ARCHITECTURAL REVIEW FINDINGS AND DECISION

**** APPROVAL WITH CONDITIONS ****

Case #: AR-15-0025
Project: Cracker Barrel at Nyberg Rivers
Location: [7665 SW Nyberg St.](#) (Tax Lot 2S1 24AD 3100)
Applicant: LD Reeves and Associates, Inc.; Loretta Reeves, 1889 Manzana Ave, Punta Gorda, FL 33950
Project Contact: DOWL; Read Stapleton, rstapleton@dowl.com; 720 SW Washington St, Ste 750, Portland, OR 97205 (971) 280-8641

SOUTH ELEVATION

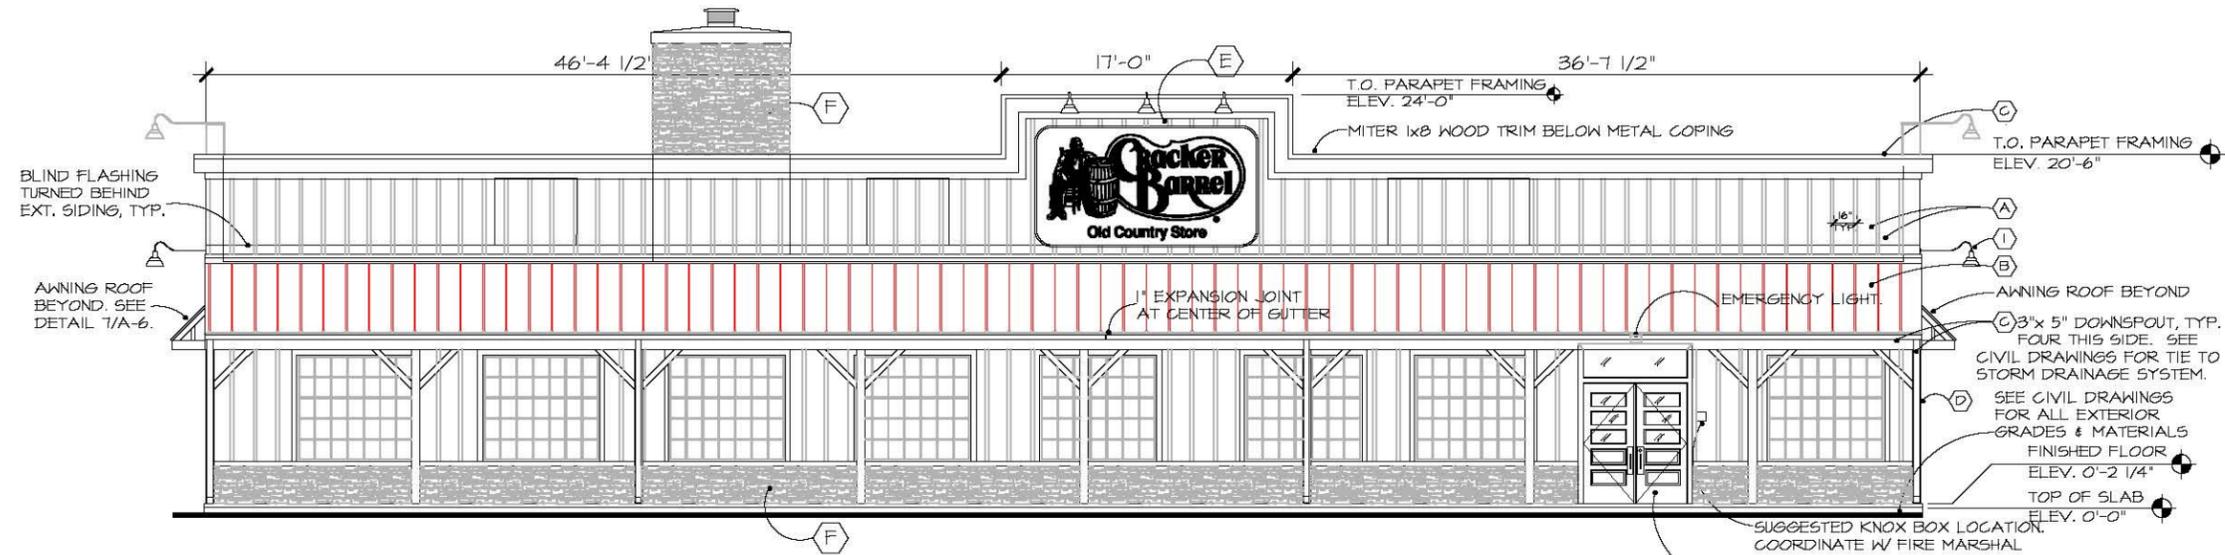
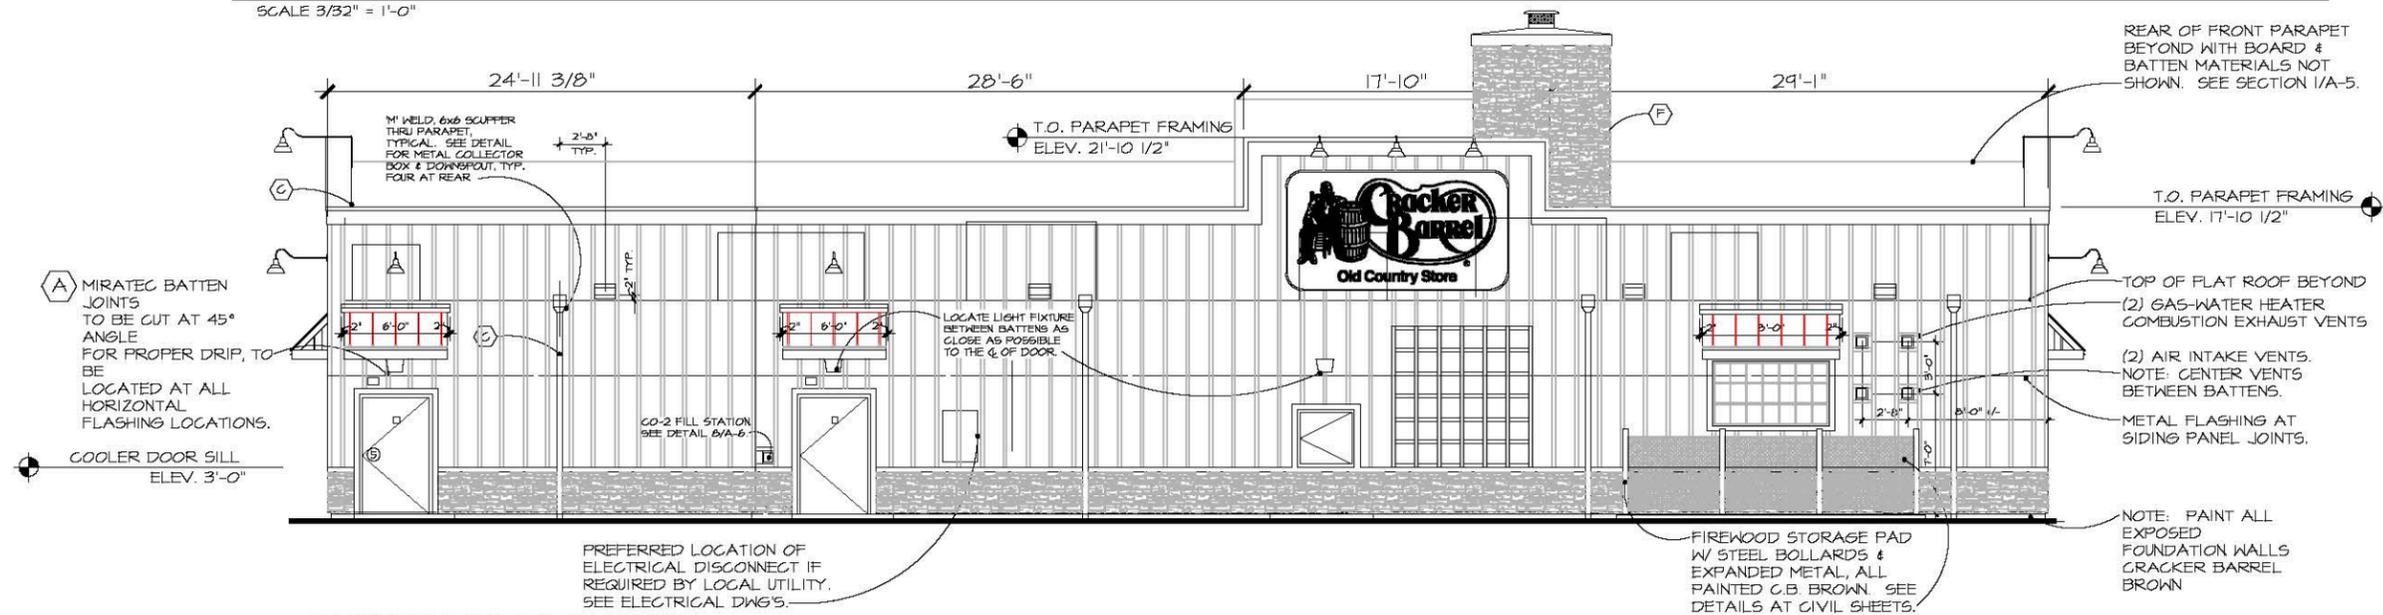
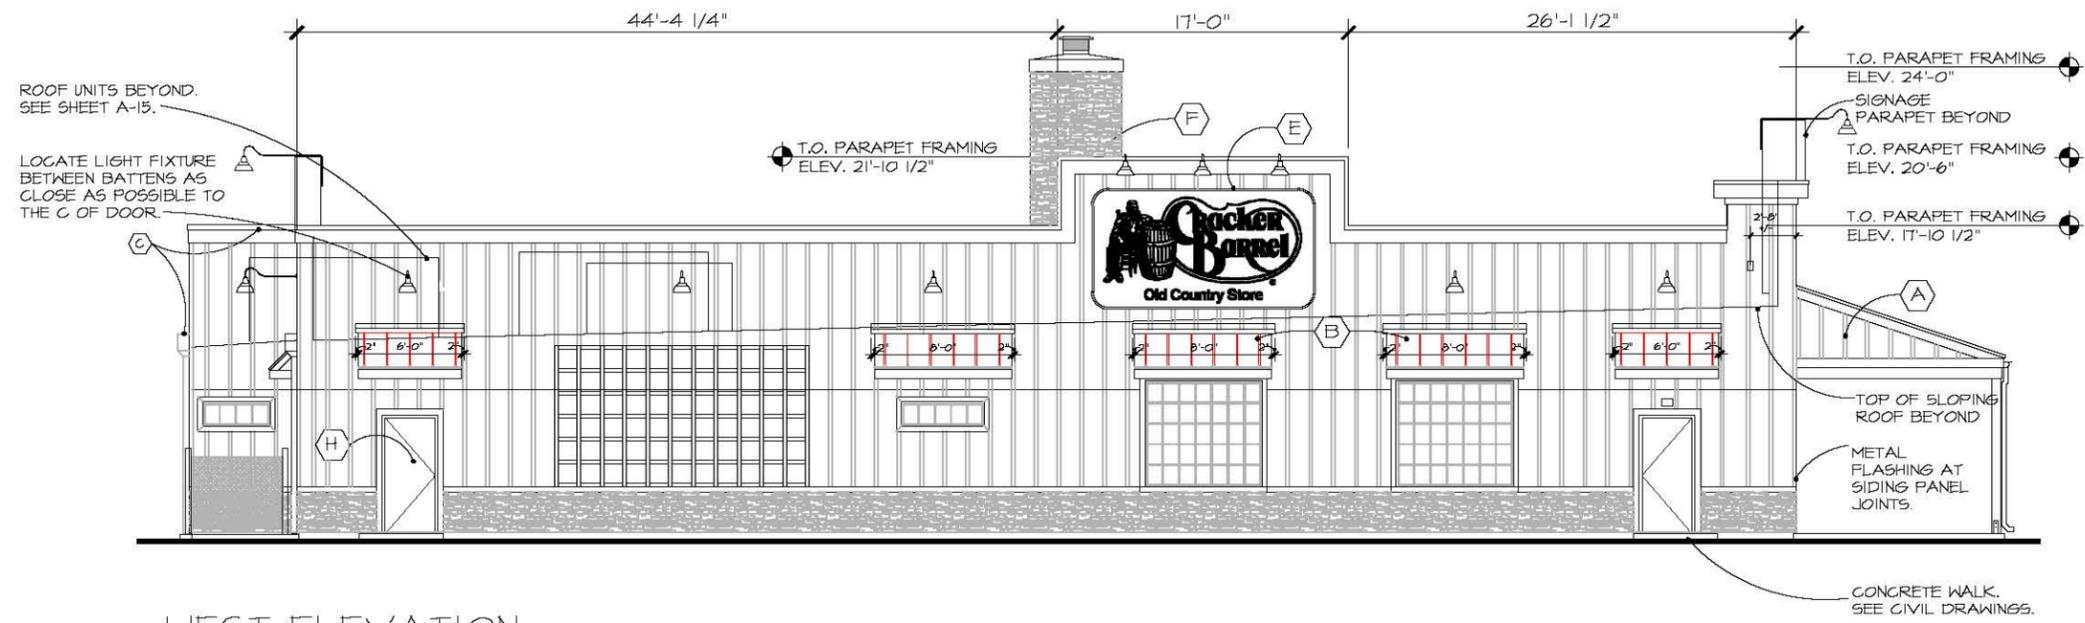
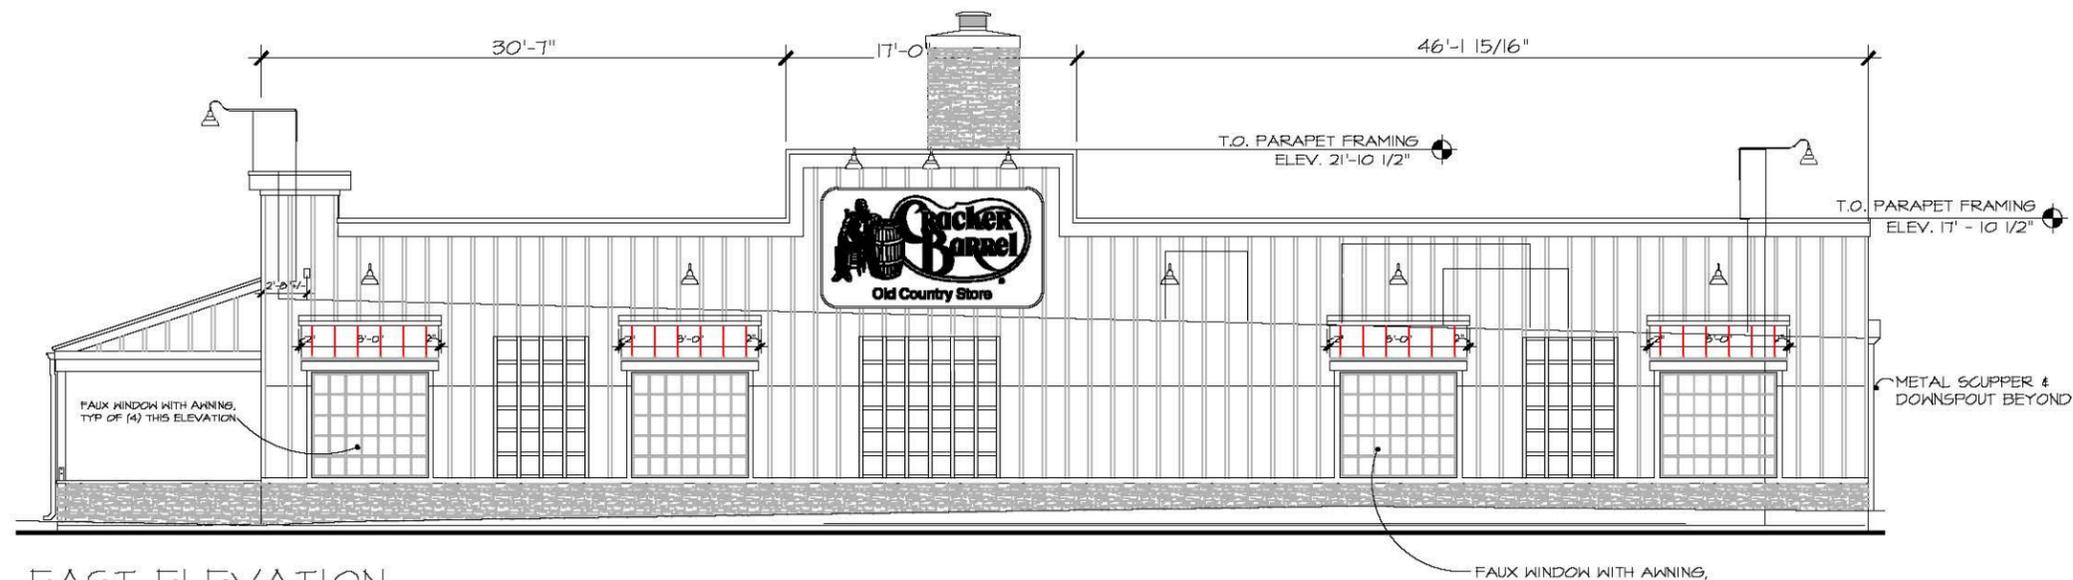
No rooftop equipment is shown on the proposed elevations. Parapet shall screen any roof top units. Applicant is conditioned to submit revised plans with conceptual roof top units to conform with screening requirement.

Condition of Approval: Applicant shall submit revised plans prior to issuance of building permit that demonstrate the proposed parapet adequately screens conceptual roof top units.

1 DUMPSTER ENCLOSURE FRONT ELEVATION
D-1 SCALE: 3/16"=1'-0"

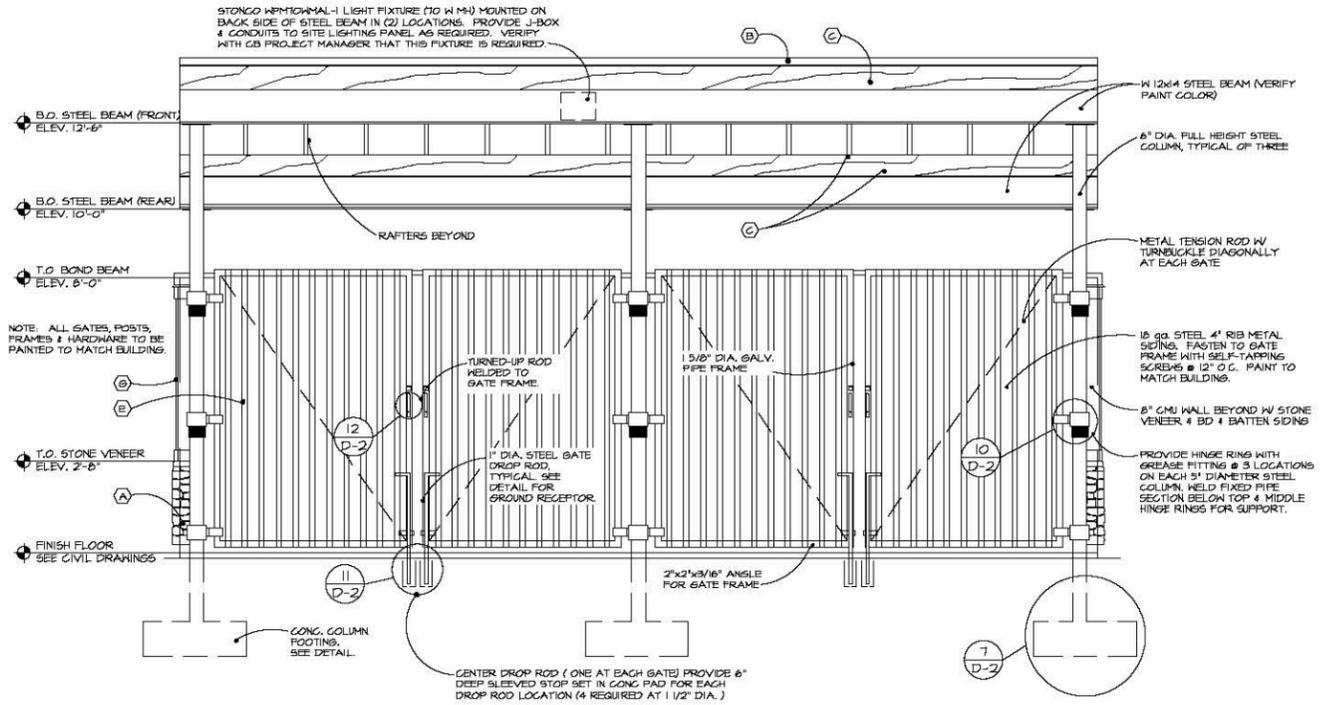
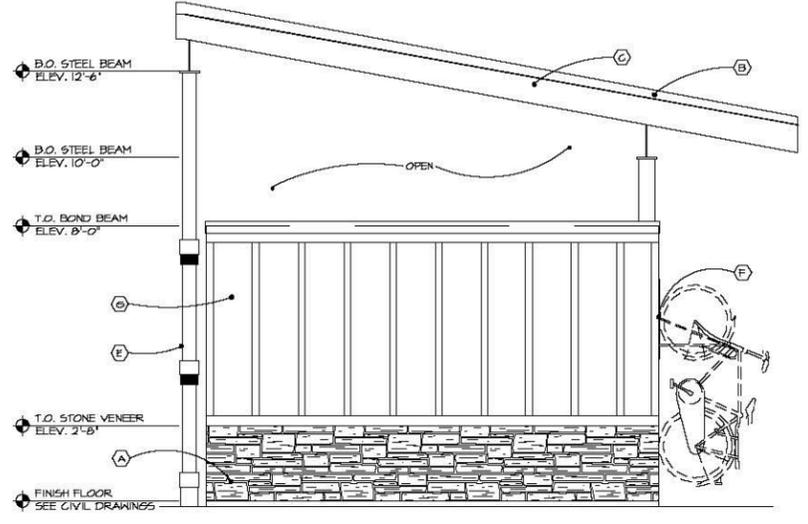
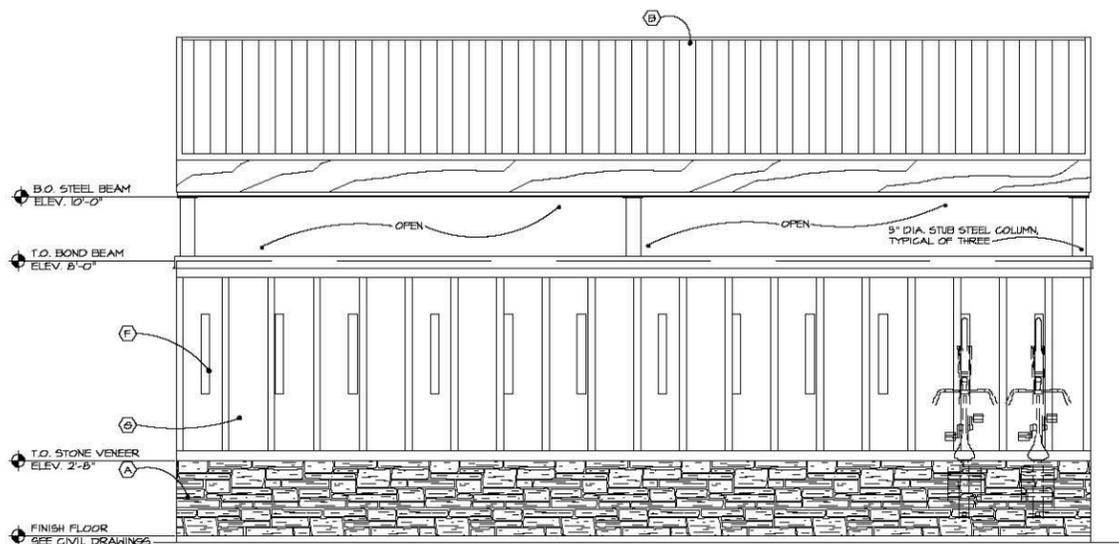
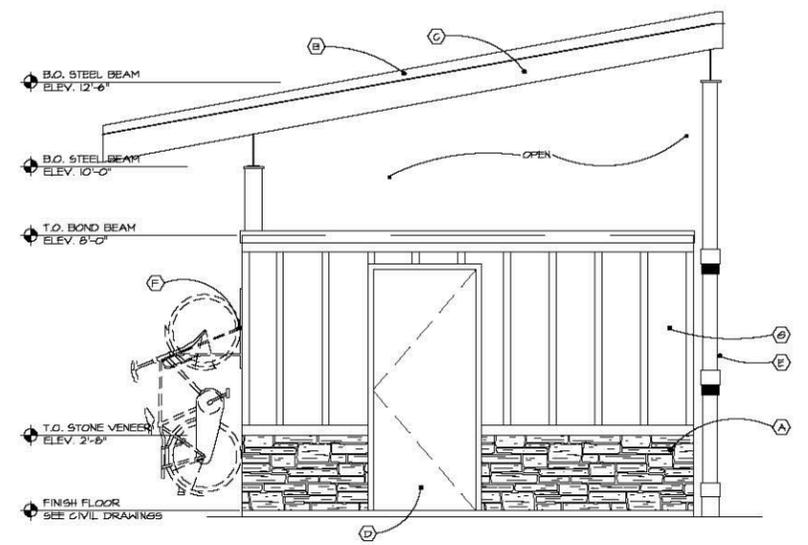
Staff notes trash enclosure plans have been provided (Sheet D-1). The plans show a walled trash enclosure that is constructed of batten siding, metal coping, and stone veneer base to match the proposed restaurant.
